**CSP-13006**

STAFF REPORT

SUBJECT: Conceptual Site Plan CSP-13006  
Type 1 Tree Conservation Plan TCP1-001-14  
Brightseat Road Property

CONCEPTUAL SITE PLAN  
CSP-13006

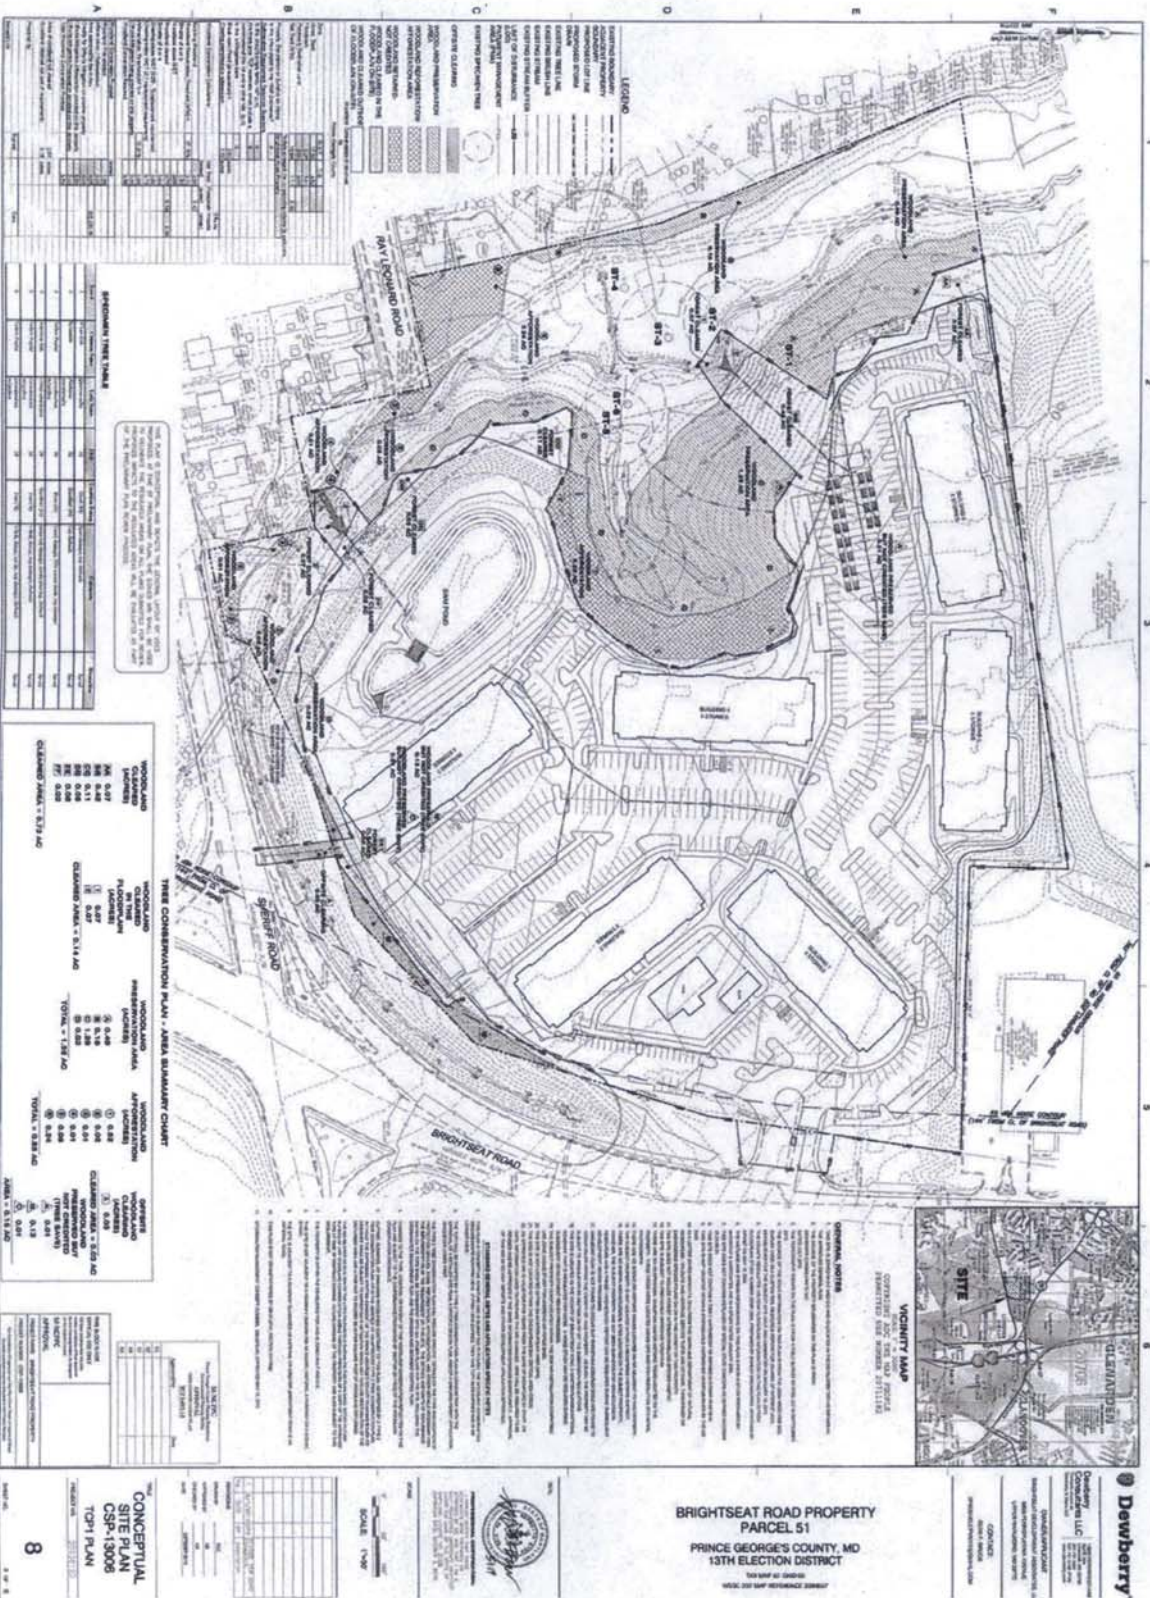
**Comment:** The design proposed for the site, even though it is for a single residential use, needs additional refinement in order to adequately reflect a cohesive development of continuing quality and stability. Therefore, various conditions have been included in this staff report concerning the design, internal circulation, and connectivity to be reviewed further at the time of preliminary plan and DSP.

**Comment:** The CSP proposes sidewalks along all internal drive aisles. No trails for recreational use are proposed. Critical pedestrian connections between the site and the Board of Education property and to Brightseat Road have been provided; however, additional design refinements are included in the Recommendation Section to encourage pedestrian activity within and through the development.

Areas of clearing, labeled as AA, CC, and DD, are shown on the plan; however, the proposed grading in these areas are not shown and it is not clear why these areas are being cleared. These areas are adjacent to, or within the PMA and are high priority areas for preservation. Development can and should be designed to preserve more of these areas up to the required minimum distances from woodland conservation (per code and the Environmental Technical Manual).

The CSP ignores the proposed thoroughfare at the north edge of the subject property onto which development is intended to face. Access to, egress from, and circulation through the site is entirely oriented to automobile use. The provision of a gated complex eliminates the type of pedestrian-orientation inherent in the envisioned development pattern. The applicant's site plan, as proposed, supports neither transit nor pedestrian activity. The provision of surface parking encourages driving, and the distance between buildings and lack of any orientation to the envisioned mixed-use street prevents the type of integrated, walkable community envisioned by the Sector Plan. The proposed development is inherently suburban in its layout, amenities, and density.

1. Prior to certificate approval, the CSP shall be revised as follows:
  - a. Show the bearings and distances of subject property on Sheets 1, 5, 7, and 8.
  - b. Delineate a street from Brightseat Road that connects to the property to the north, Parcel 56. The street should be consistent with the 2009 *Approved Landover Gateway Sector Plan and Proposed Sectional Map Amendment* and accessible to the public.

- c. The plan shall be revised to show the bearings and distances of the subject property on Sheets 1, 5, 7 and 8.
  - d. The CSP shall be revised to conceptually show a roadway that extends from the proposed access location at Brightseat Road in a westerly direction through the subject property connecting to the property to the north, Parcel 56. Notes on the plan shall indicate that the roadway will be accessible to the public.

Conceptual Site Plan CP1  
Brightseat Road Property

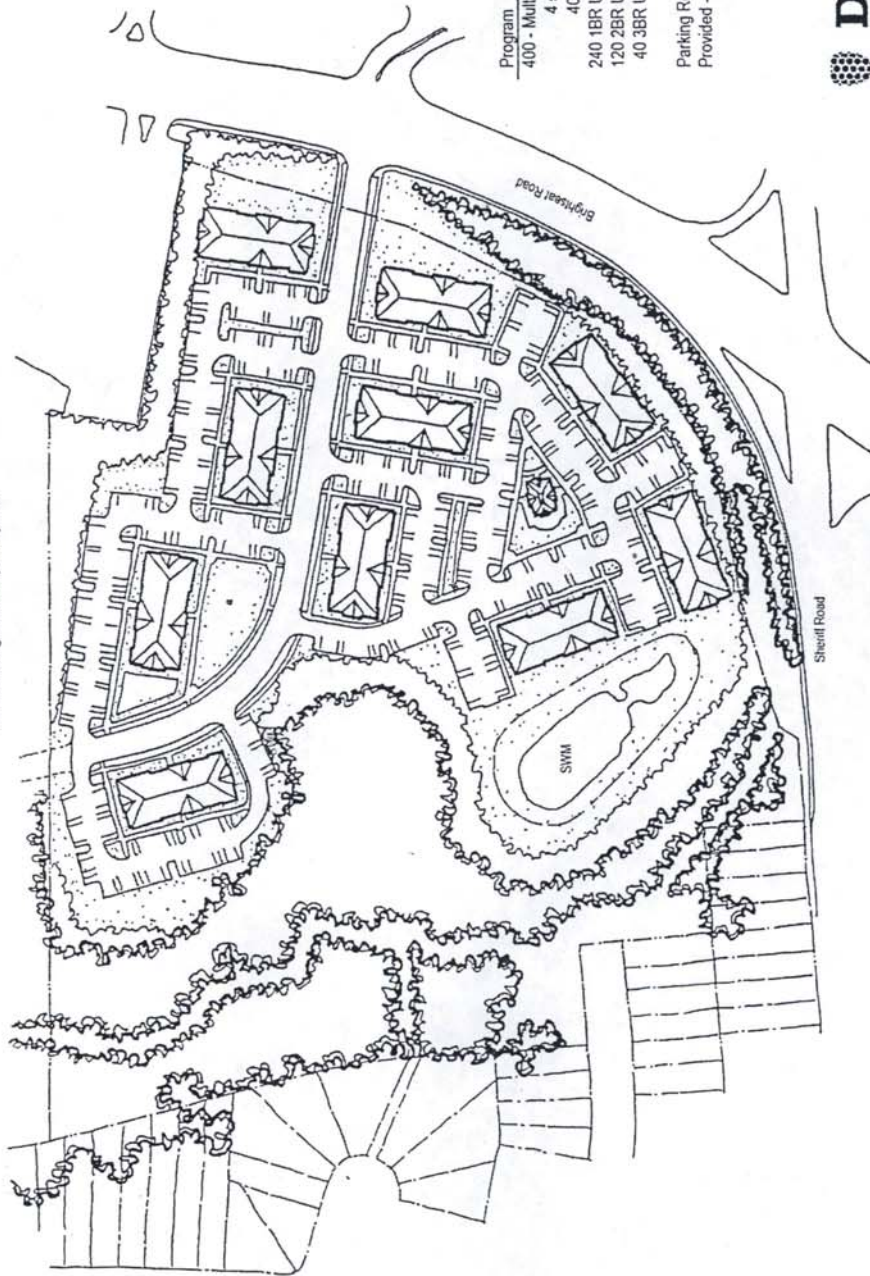
In the original traffic study dated December 2012 that applicant submitted to staff, the traffic study included Exhibit 1A Conceptual Site Plan Brightseat Road Property that depicts the site layout for 400 multifamily units with a roadway from Brightseat Road to northeastern property line. The site layout in Exhibit 1A addresses the issues related to the approved Landover Sector Plan, Transportation Review Guidelines and Subdivision Regulations. The CSP should be revised to reflect the site layout on Exhibit 1A.

1. Prior to certificate approval, the CSP shall be revised as follows:
  - a. Show the bearings and distances on subject property on Sheet 1, 5, 7 and 8.
  - b. Delineate a street from Brightseat Road that connects to the property to the north, Parcel 56. The street should be consistent with the approved Section Plan and accessible to the public.

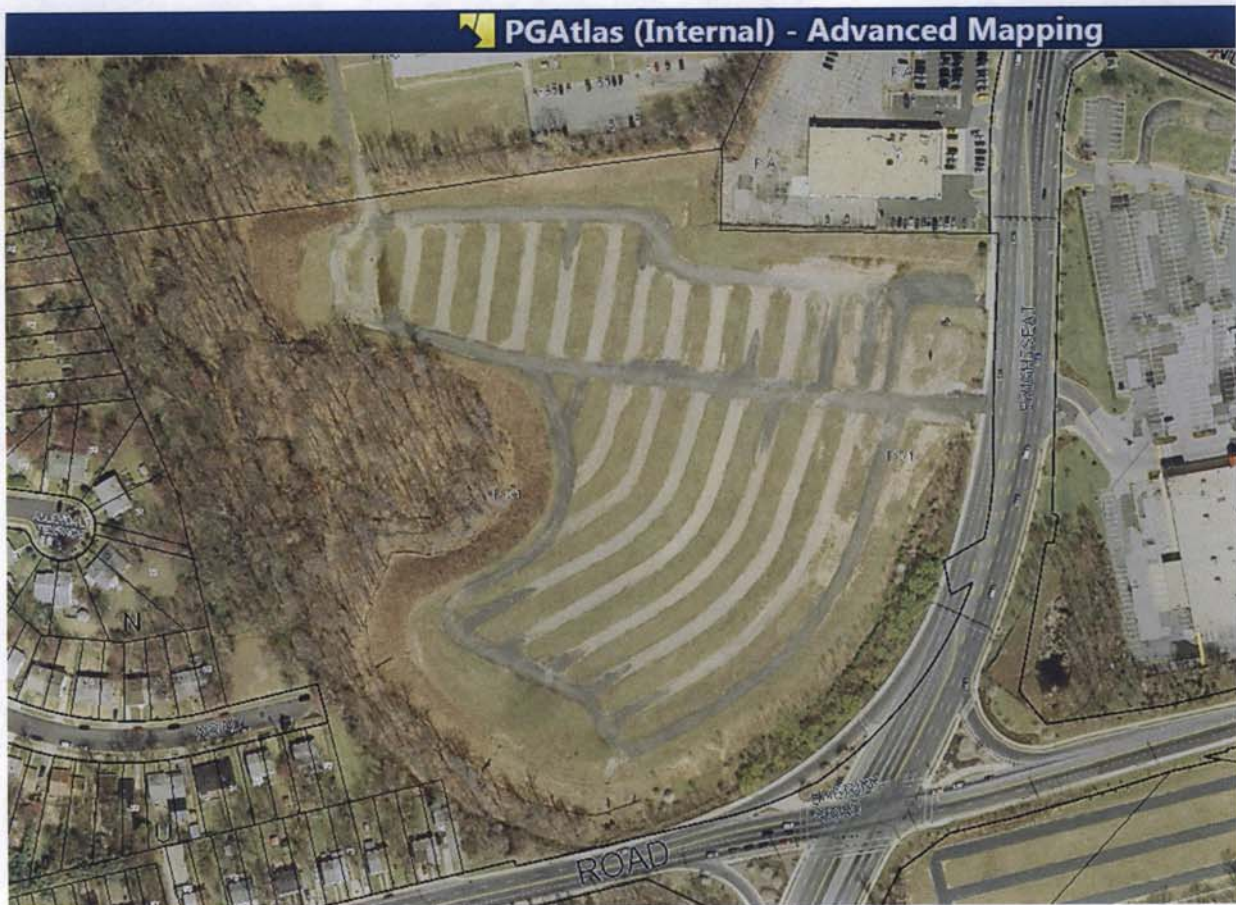
The applicant submitted an additional memorandum dated May 1, 2014 that discusses the master plan facilities recommended in this memorandum and included in the area master plan. Based on a review of this additional information, staff includes the following discussion and has made slight modifications to one recommended condition.

- The applicant states that both Sheriff Road and Brightseat Road are State rights-of-way and conclude that "it is highly unlikely that MDSHA will allow any changes to the current sidewalk and lane alignment". After further review, it was determined that Sheriff Road is maintained by DPW&T and Brightseat Road is operated by SHA. However, the recommendations regarding the planned bicycle and pedestrian facilities remain unchanged regardless of the ultimate operating agency. Staff continues to recommend frontage improvements consistent with the master plan along both Sheriff Road and Brightseat Road, unless modified by the appropriate operating agency. The recommended condition has been modified however to reflect that Brightseat Road is operated and maintained by SHA, not DPW&T.

- The applicant states that the trail along the stream valley is not feasible due to the existing stream and environmental constraints, as well as the topography abutting Sheriff Road. However, staff is not recommending the trail within the environmental setting, but on the periphery of the developable portion of the site adjacent to the PMA. Alternative layouts provided by the applicant have appeared to indicate that space for a trail can be provided at this location. Staff concurs that due to steep and severe slopes between the site and Sheriff Road, it will likely not be feasible to construct the trail all the way to Sheriff Road. However, the trail will still serve as a private HOA outdoor recreational amenity for use by the future residents of the site, with a potential connection to the property to the north. Staff continues to feel that the master plan trail along the stream valley will serve as a needed public amenity for the future residents of the site.
